Ref: 188-002-007L

111 – 119 Port Douglas Road, Port Douglas – Civil and Electrical Works OP 2021-4246/1 Response to Information Request

We refer to Council's information request dated 9 August 2021 (copy attached) for the abovementioned application and respond to each of the items below.

Refer to drawing 188-002-SK10 that confirms the design service vehicle can negotiate through the development as requested.

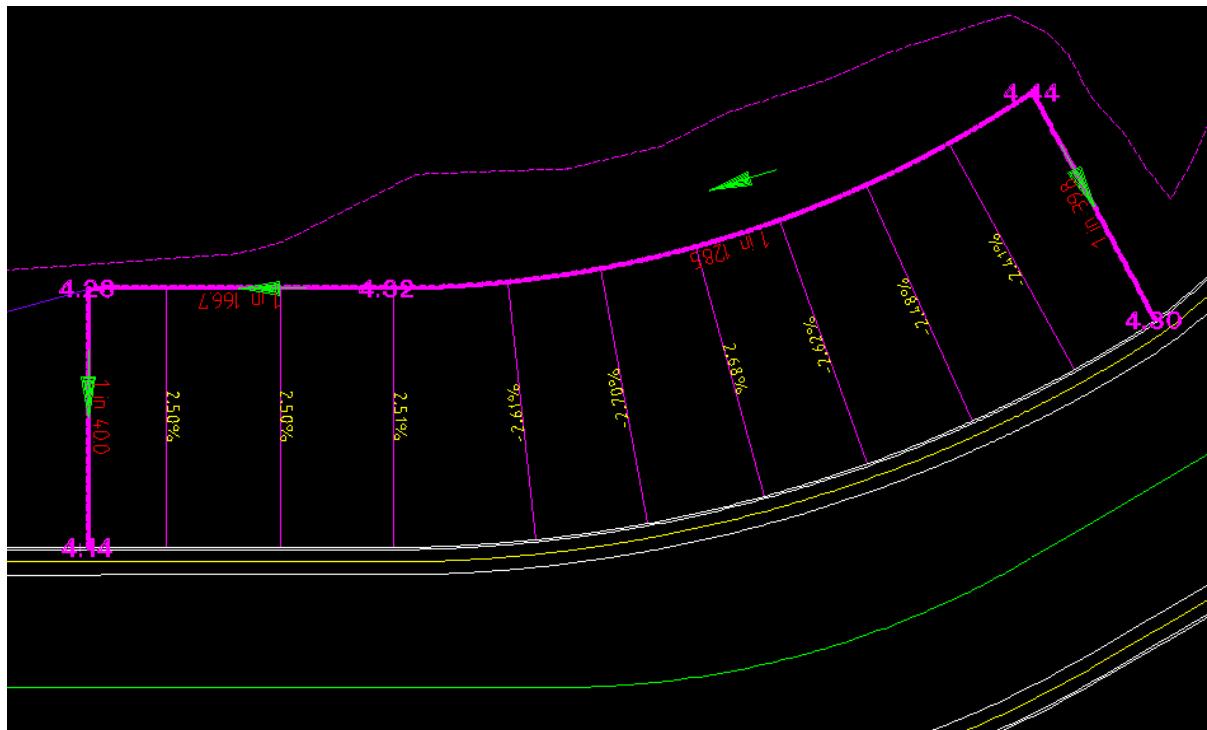
Item B

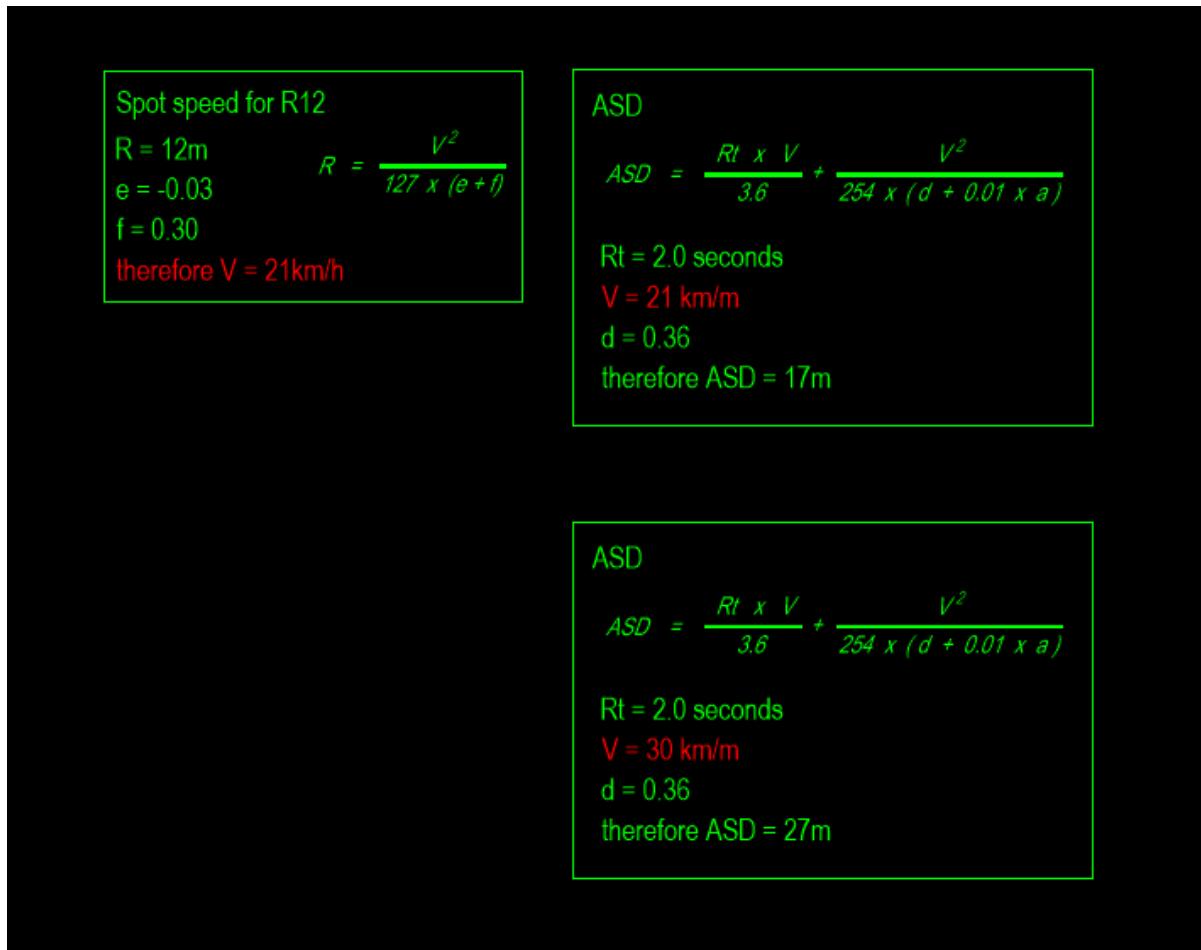
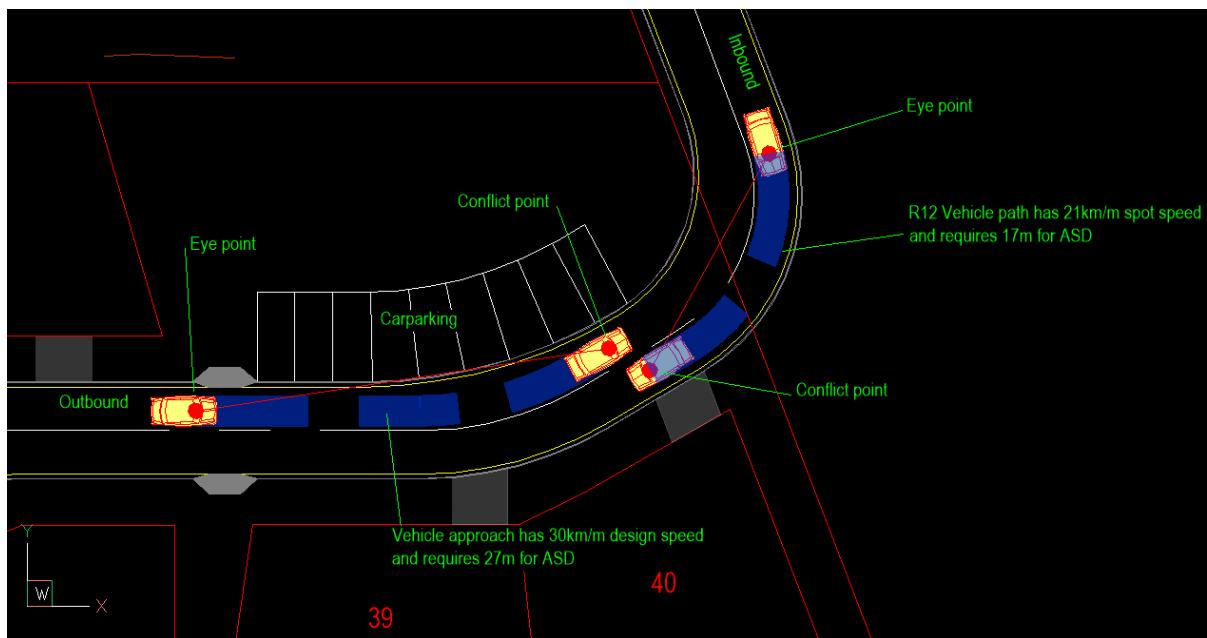
Item F

Reference is made to the images below which demonstrate compliance with Austroads requirements for approach site distance (ASD). The first image provides calculation of the “spot” speed around the entrance curve at approximate chainage 40 (21km/h) for an entering vehicle. It also provides calculation for the associated ASD, being 17m. The second calculation provides ASD (being 27m) for a vehicle travelling at a speed of 30km/h at approximate chainage 80 as it travels to the development exit.

The second image provides a pictorial on vehicle positions relative to conflict points for the above calculations and demonstrates that the calculated ASDs are available.

CAR PARK DETAIL - PARALLEL TO ROAD

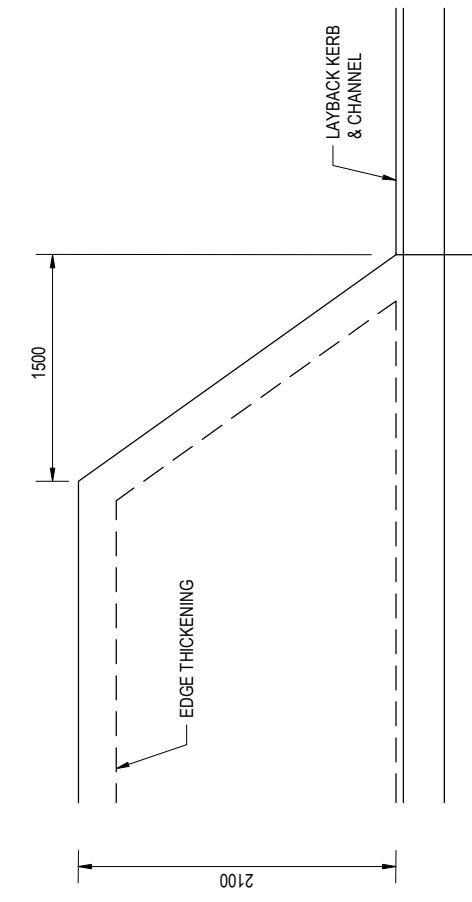
Item C

The car park detail on drawing 188-002-C08 has been updated so that the park crossfall matches that of the 3% verge.

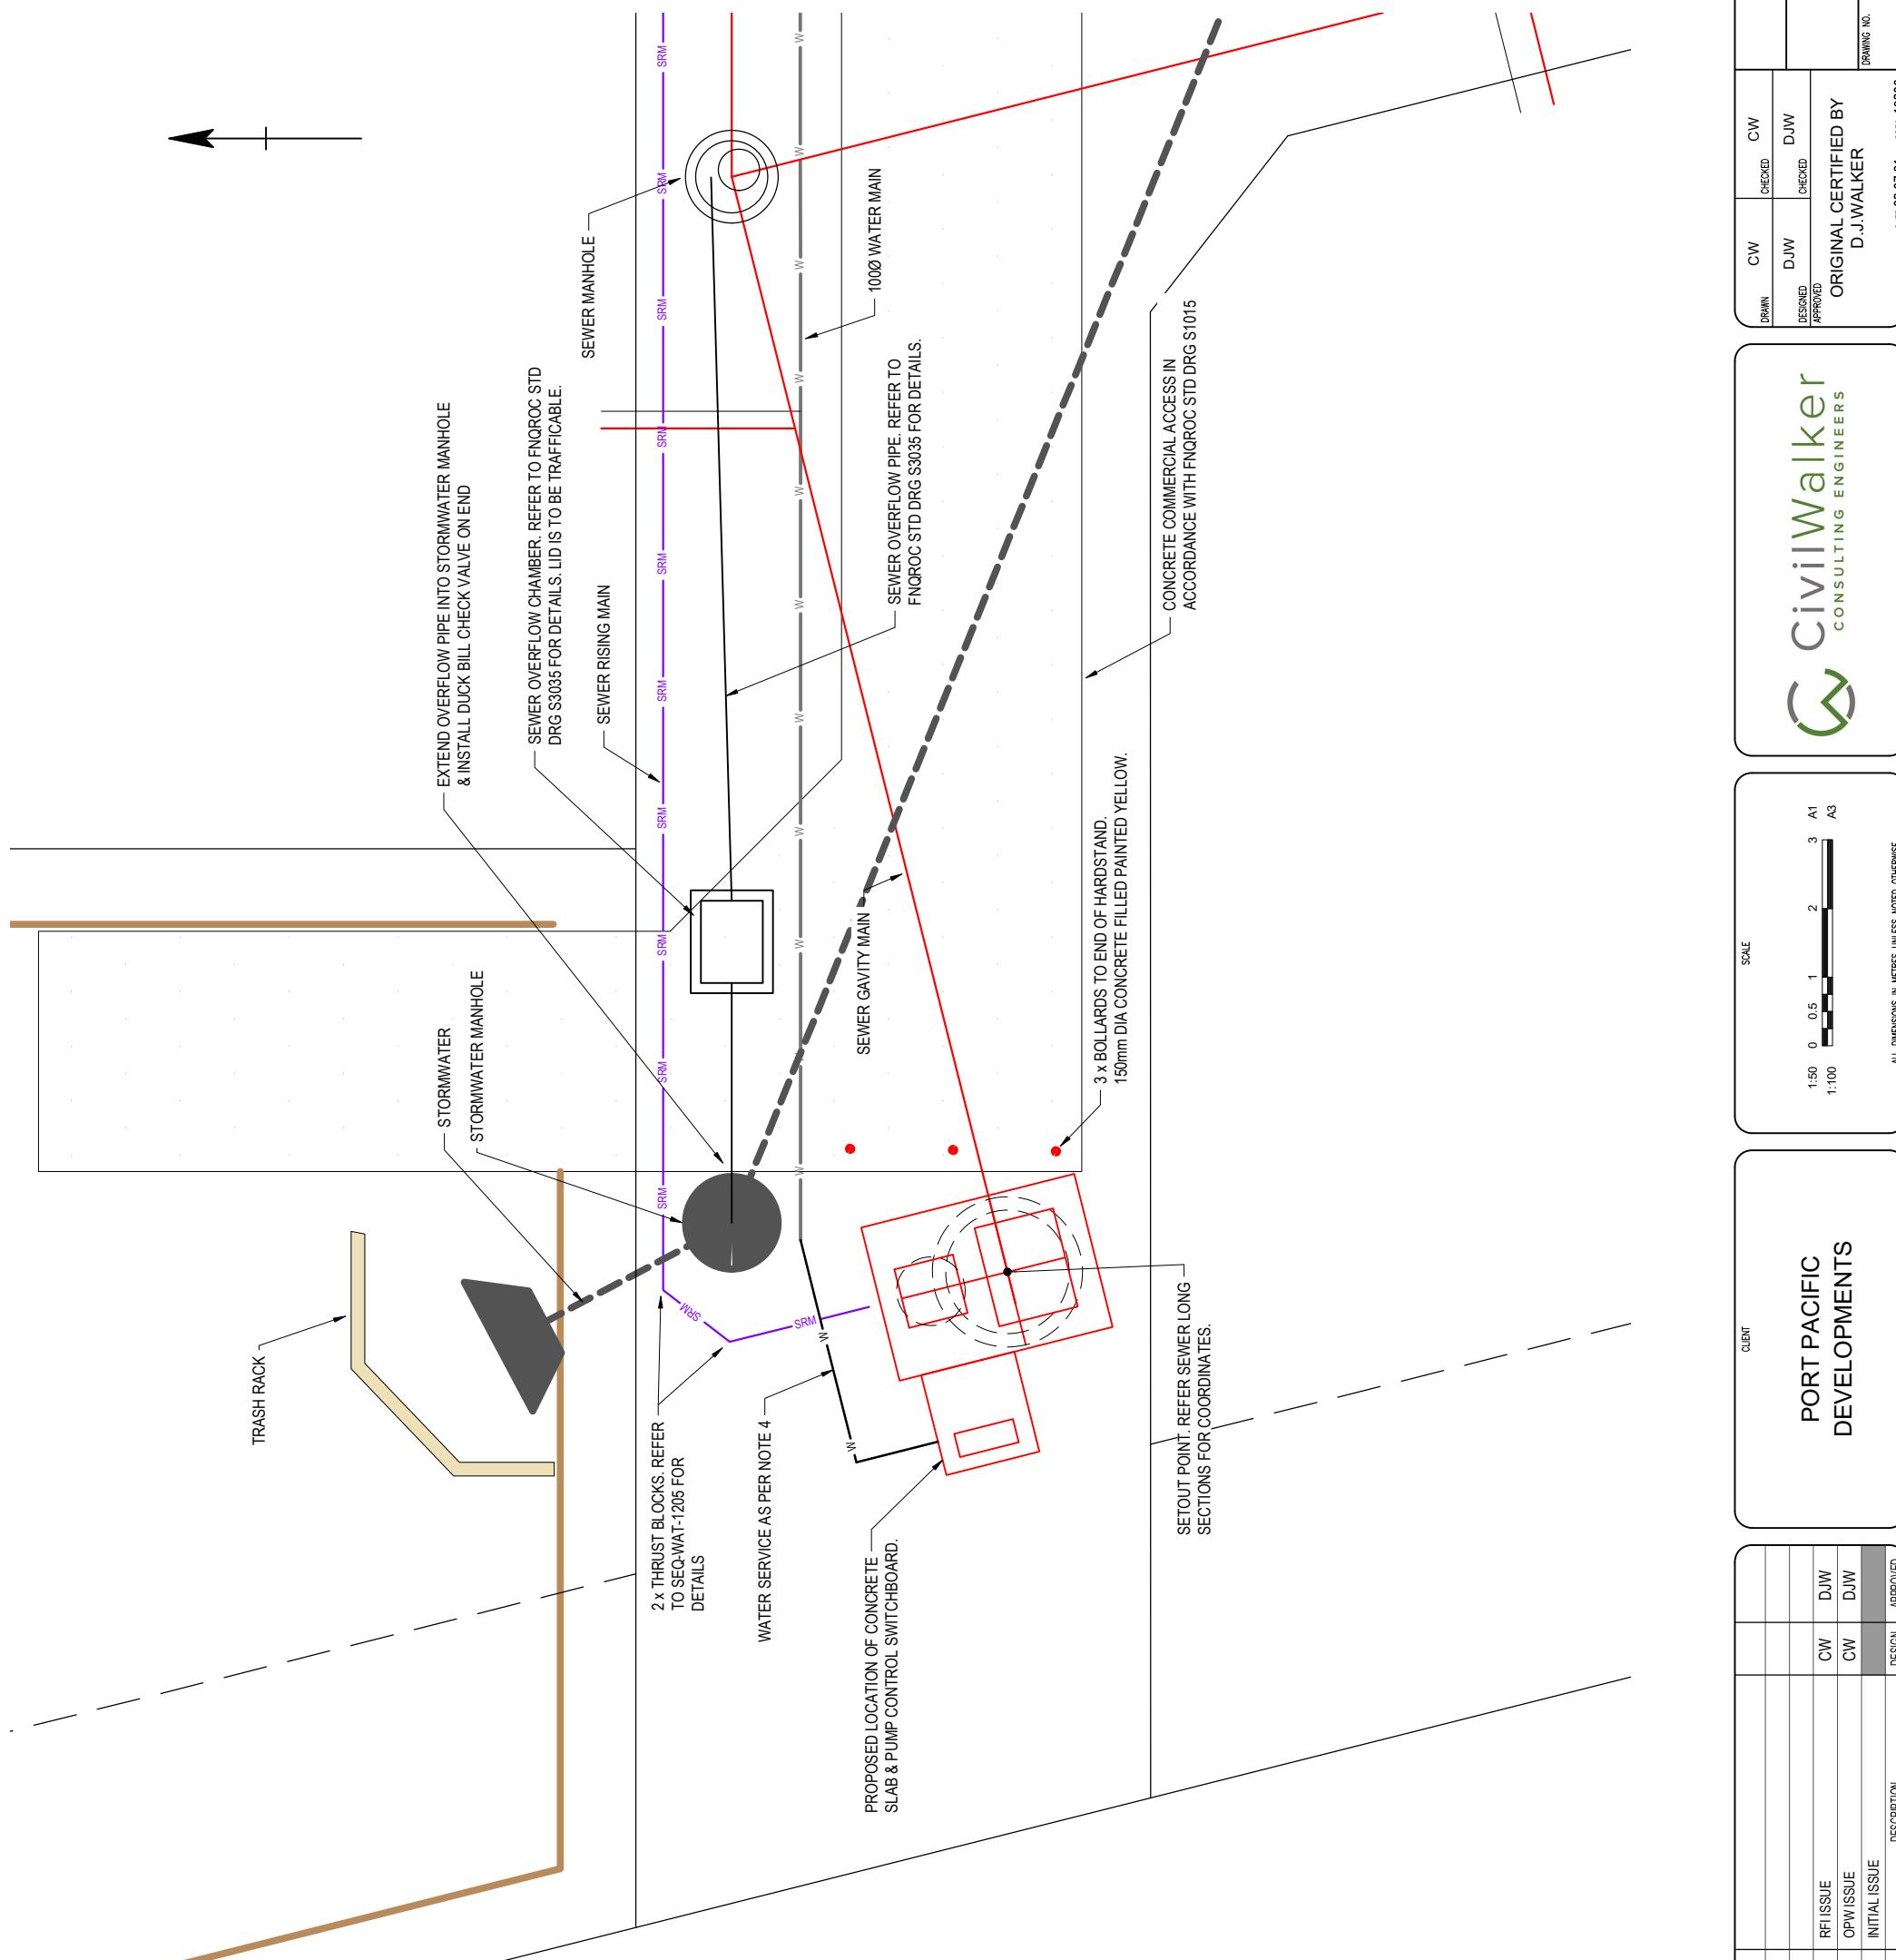
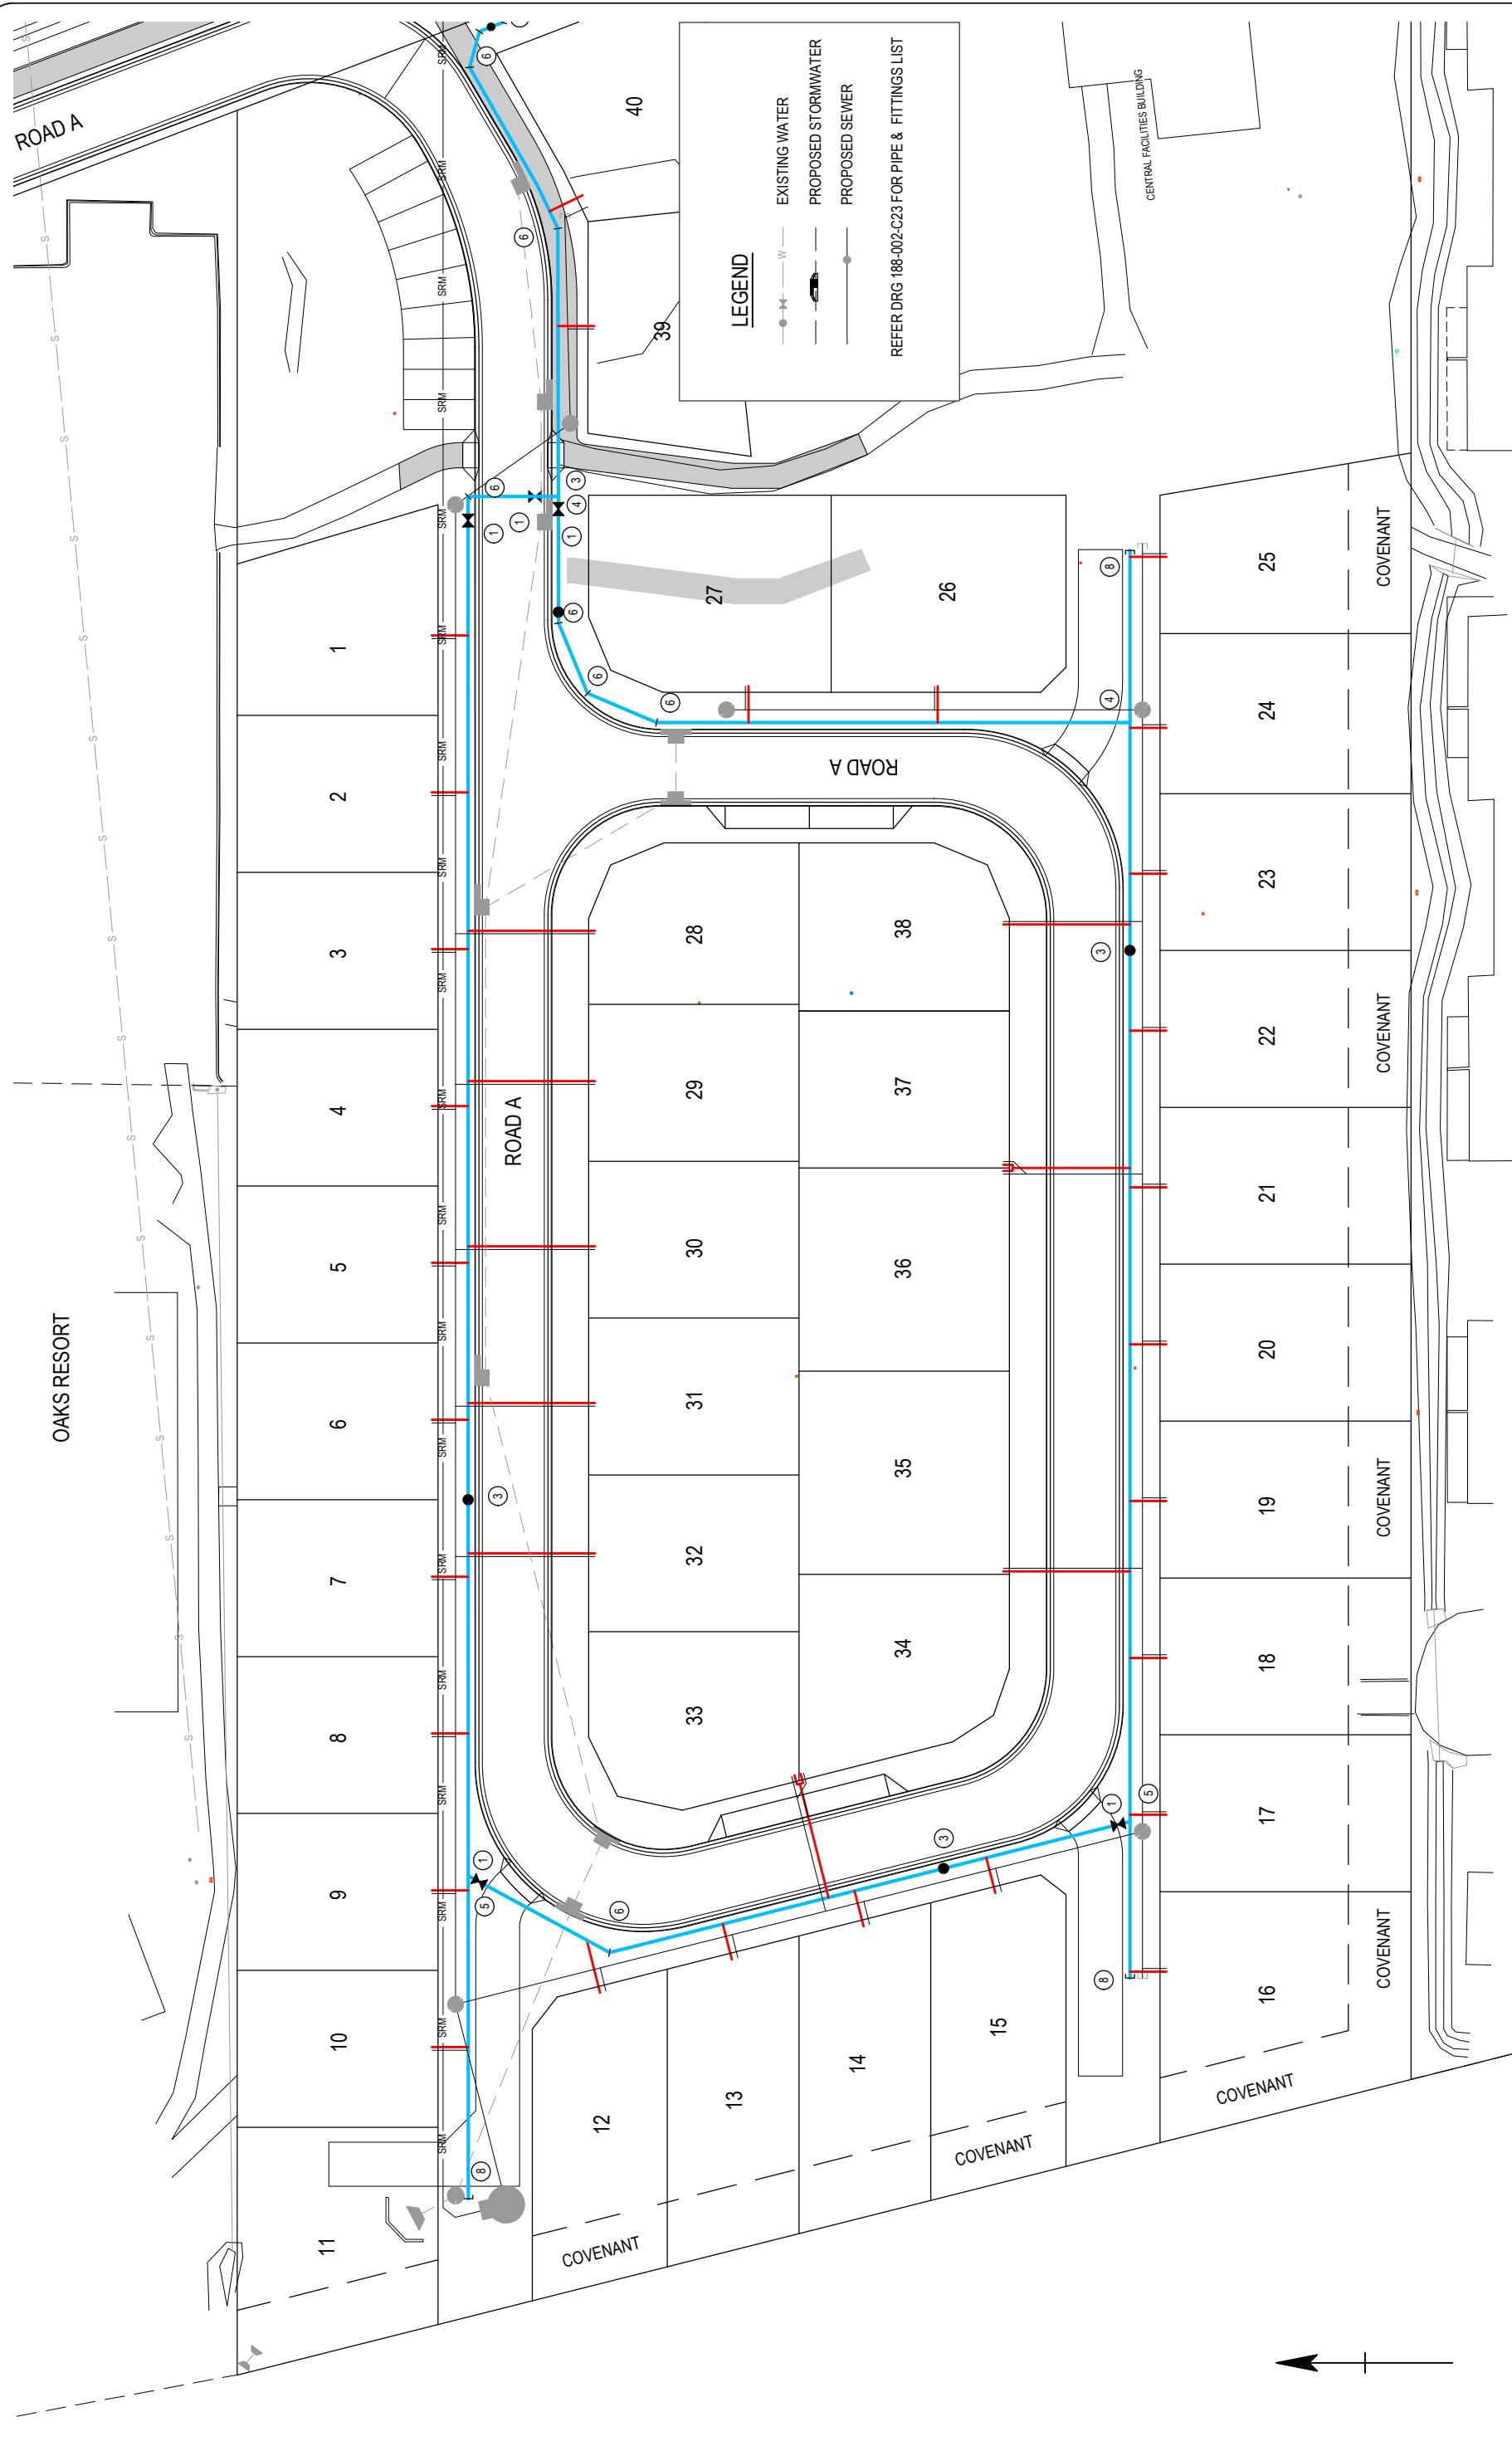
Item C

Item D

The note on drawing 188-002-C21 has been adjusted.

The duckbill check valve will be installed on the end of the overflow pipe, which will extend into the stormwater manhole to allow for the valve installation. Drawing 188-002-C21 has been updated to clarify this.
